SUBJECT: U. S. NUCLEAR REGULATORY COMMISSION REVIEW OF HOMESTAKE MINING COMPANY OF CALIFORNIA'S REPLY TO "RESPONSE TO THE HOMESTAKE MINING COMPANY OF CALIFORNIA LETTER, DATED JULY 26, 2018: PROPOSED ADJUSTMENT IN GROUNDWATER MONITORING OF THE SAN ANDRES-GLORIETA AQUIFER NEAR THE GRANTS RECLAMATION PROJECT", DATED MAY 10, 2019, DOCKET NO. 040-08903, LICENSE NO. SUA-1471

RESULTS OF U.S. NUCLEAR REGULATORY COMMISSION STAFF REVIEW OF THE MAY 10, 2019, "RESPONSE TO THE HOMESTAKE MINING COMPANY OF CALIFORNIA LETTER, DATED JULY 26, 2018: PROPOSED ADJUSTMENT IN GROUNDWATER MONITORING OF THE SAN ANDRES-GLORIETA AQUIFER NEAR THE GRANTS RECLAMATION PROJECT"

HOMESTAKE MINING COMPANY OF CALIFORNIA
GRANTS RECLAMATION PROJECT

Figure 1. Water level elevations for Alluvial wells 556, 844, and 845 (adapted from April 3, 2018, Well 943 Hydrologic Test Report)

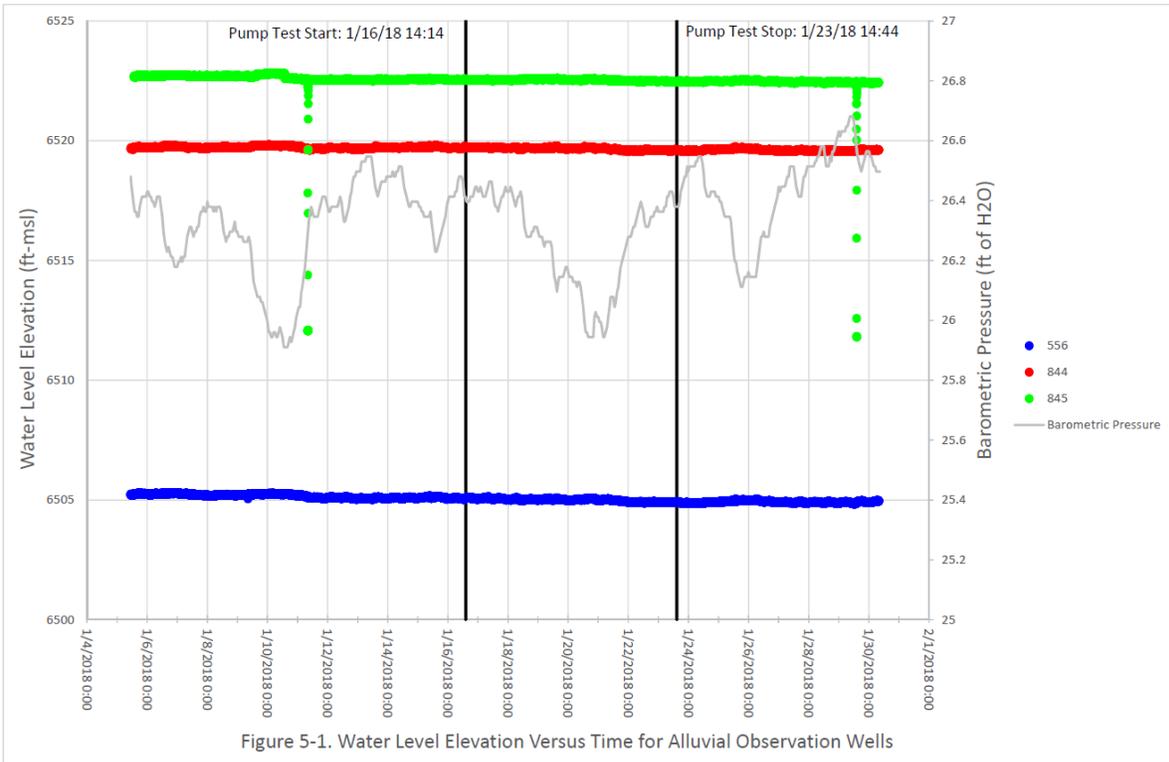
In review of any other potential sources of the contamination observed at well 943, the NRC staff, in coordination with the Agencies, reviewed additional groundwater monitoring data. Figure 1 and Figure 2 of this report show water level elevations from the April 3, 2018, Well 943 Pump Test Report for the Alluvial and Middle Chinle Aquifers, respectively. As shown in Figure 1 and Figure 2, the pump test stopped on January 23, 2018, and the well monitoring data stopped on January 30, 2018. The pump test data shown in Figure 1 and Figure 2 did not show any drawdown in the Alluvial⁸ or Middle Chinle Aquifers during the pump test. However, the water elevations measured on February 6, 2018, and shown in Figure 3 and Figure 4 of this report, which were adapted from the 2018 Annual Monitoring Report, showed drawdown for several Alluvial wells and Middle Chinle well CW76, which are in the vicinity of well 943. In addition, a similar trend in well drawdown was observed during the February 6, 2018, sampling event for several Alluvial wells located further away in the 100-Acre Center Pivot area, as shown in Figure 5 of this report. It is not clear if the drawdown in these wells was related to other HMC activities (e.g., well sampling, groundwater extraction) or if the drawdown was delayed and was related to the well 943 pump test. The NRC staff, in coordination with the Agencies, note that there is the potential for an additional source(s) of contamination into the SAG Aquifer that has

1. Provide clarification as to the cause of the well drawdown observed in wells 555, 556, 844, and 845 as well as the wells located in the 100-Acre Center Pivot area (i.e., wells 881, 882, 884, 886, 893). In the 2018 Annual Monitoring Report, HMC did not discuss the decreases observed in these wells during the February 6, 2018, well sampling event. If the observed delayed well drawdown in could be related to the 943 well pump test, HMC should investigate and report on the potential pathway(s) from the Alluvial Aquifer to the SAG Aquifer during the pump test.

Figure 2. Water level elevations for Middle Chinle wells 821, CW15, CW30, CW75, CW76, and CW77¹¹ (adapted from April 3, 2018, Well 943 Hydrologic Test Report)

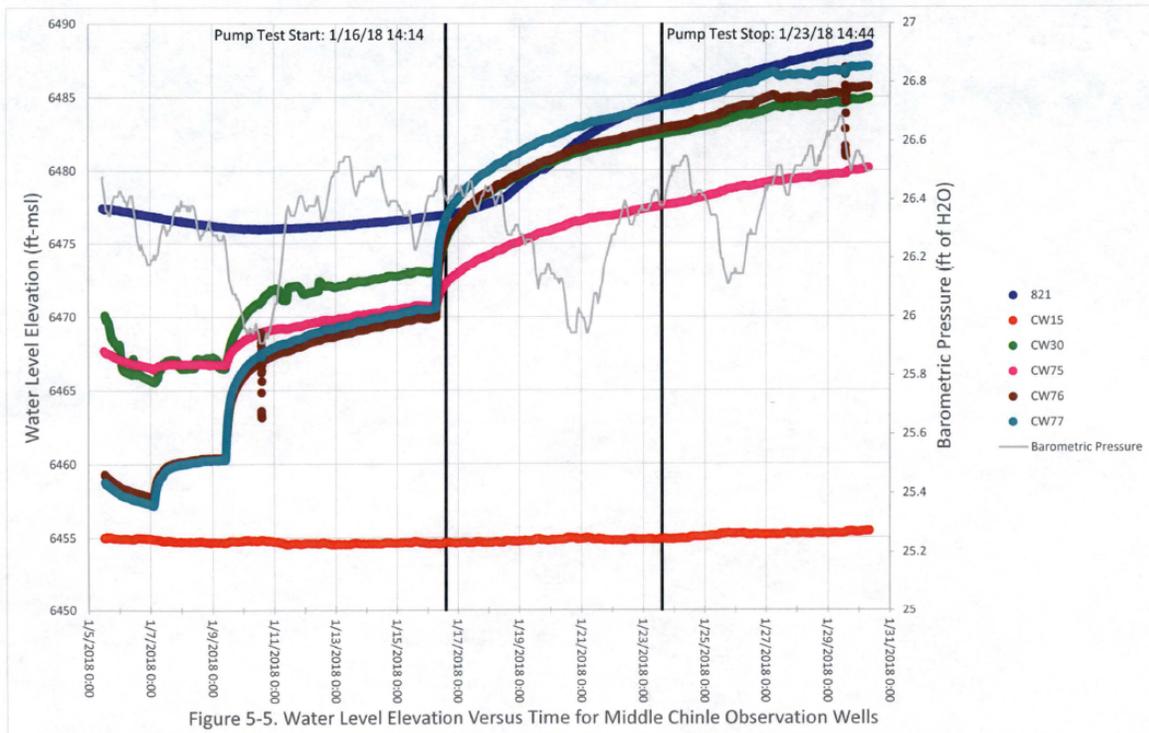
¹¹ In the report dated April 3, 2018, HMC described the rise in water level elevations for these Middle Chinle wells as being due to a series of collection wells being turned off.
